VALUE ENGINEERING MOD 1 TRAINING REPORT

SR 20 / Loganville Highway
Ozara Road to Brand Road

Project No. MSL00-0004-00(644)
Gwinnett County
PI No. 0004644
February 18, 2009

DEVELOPMENT PHASE - EXECUTIVE SUMMARY	
Project: SR 20 / Loganville Highway	Team: 3
Location: Gwinnett County	Date: 1/30/09

S. R. 20
 TANGENT SECTION
 STA. 103+92.11 - 174+56.71
 STA. 198+10.73 - 232+00.00

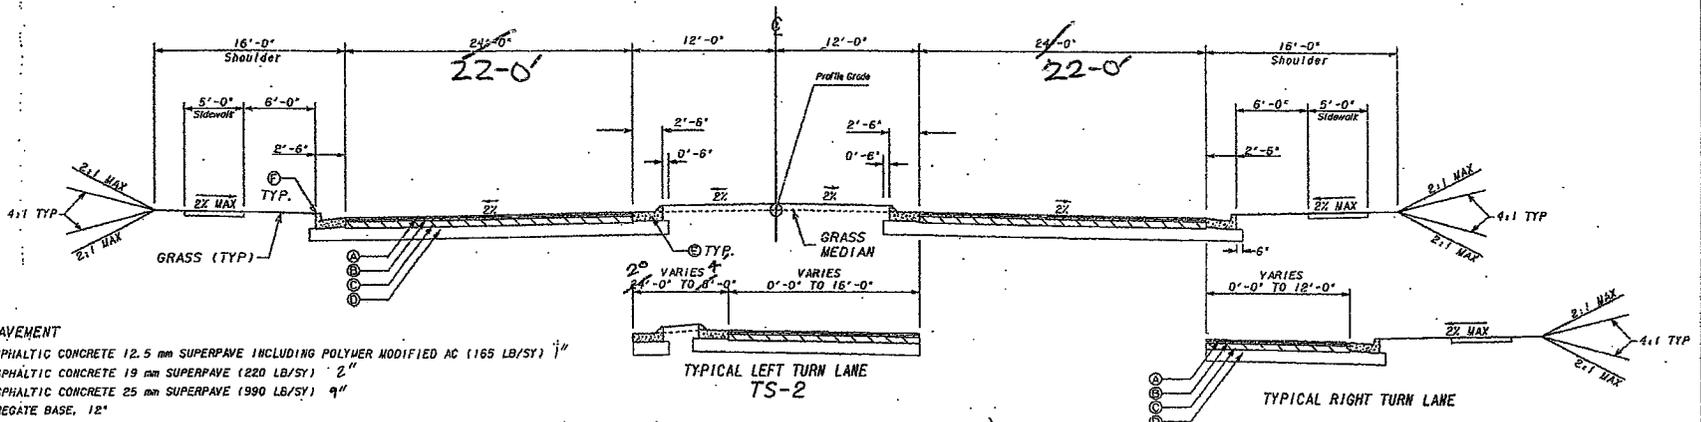
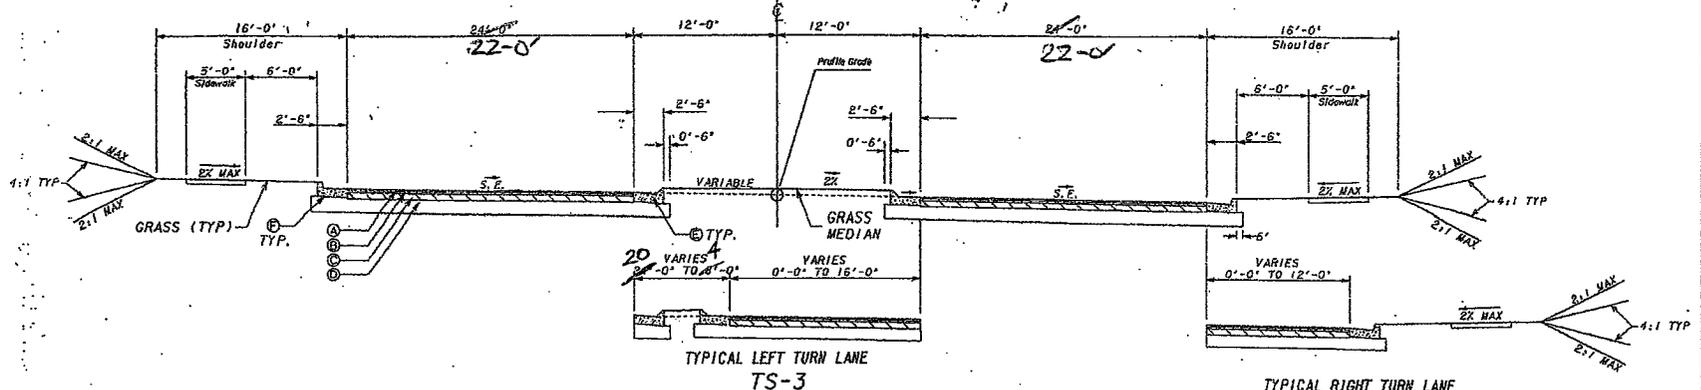
Idea No.: A-2	Sheet No.: 1 of 4	CREATIVE IDEA: REDUCE THE PROPOSED LANE WIDTHS FROM 12 FEET TO 11 FEET.
-------------------------	-----------------------------	---

Original Concept: The original proposed concept includes 4-12 foot travel lanes for the typical section

Proposed Change: The proposed VE changes use 11-foot lanes for the typical section.

Justification: This is an urban section that has a design speed of 45mph. Using an urban section with that speed, the 11 foot lanes should function similar to the 12 foot lanes without any significant issues.

Decreasing the pavement width will result in grading, cross drain pipe lengths and earthwork.

Idea No.: A-6
Client:
Sheet of

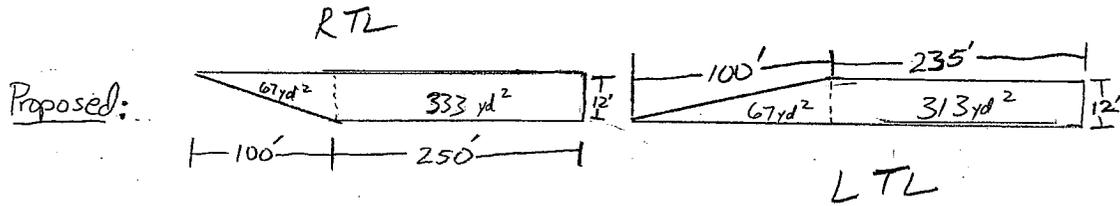
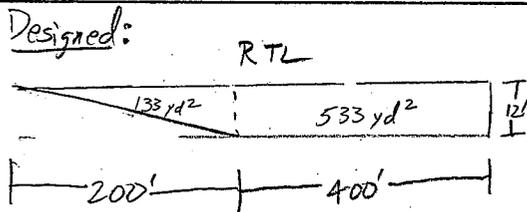
DEVELOPMENT AND RECOMMENDATION PHASE			
Project: SR 20/LOGANVILLE HWY FM OZORA RD TO BRAND RD-GRTA			
Idea No.: A-6	Sheet No.: 1 of 3	CREATIVE IDEA: Reduce the length of the turning lane	
Comp By: PA	Date: 1/29/09	Checked By:	Date:
<p><u>Original Concept:</u> The current project proposes to construct 600' turn lanes (400' storage with 200' taper)</p> <p><u>Proposed Change:</u> Reduce turn lanes to minimums as required in GDOT Driveway & Encroachment Control Manual.</p> <p><u>Justification:</u> The minimum required lengths based on 45mph are 235' storage with 100' taper for left turn lanes and 250' storage with 100' taper for right turn lanes. Based on a review of the design hour volumes the proposed turn lane lengths can be reduced. This modification will reduce overall asphalt costs.</p>			
LIFE CYCLE COST SUMMARY	INITIAL Project Cost	FUTURE Project Cost	TOTAL Present Worth Cost
<u>INITIAL COST:</u> Original
